ATTACHMENT B-1: CONDITIONS OF APPROVAL

Re: Santa Barbara County Air Pollution Control District Comments on Everbloom Cannabis, 19DVP-00000-00016/19CDP-00000-00017

- TO: Gwen Beyeler, Senior Planner Planning & Development Department
- FROM: Jason Johnston Environmental Health Services
- DATE: December 30, 2021
- SUBJECT: Case No. 19DVP-00000-00016, 19CDP-00000-00017

Project: 4701 Foothill Road Greenhouse Development Plan and Mixed-Light Cannabis Cultivation

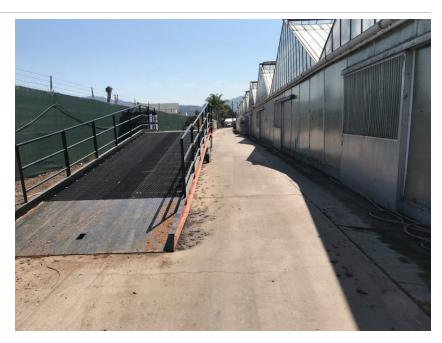
Unpermitted second story. Planned to be demoed and create a mezzanine.

Fire Alarm/Sprinkler Monitoring System

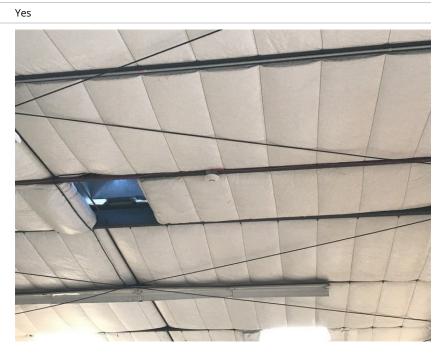
Permit for Fire alarm system and additional work required.

Housekeeping Photos

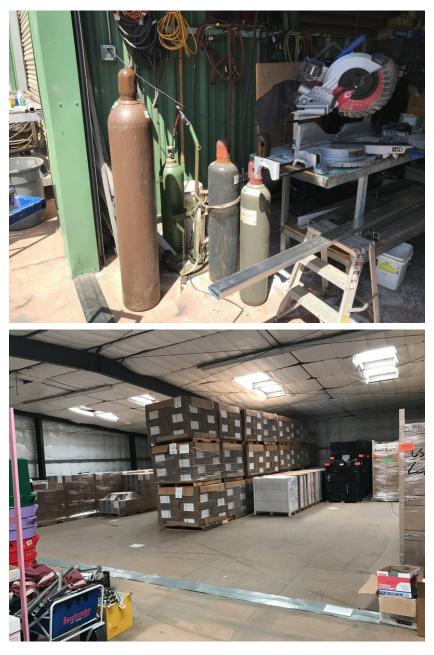
Verify the maximum allowable quantity of all chemicals.

Verify the maximum allowable quantity of all chemicals.

Remove waste oil. Relocate to an area away from the runoff pond.
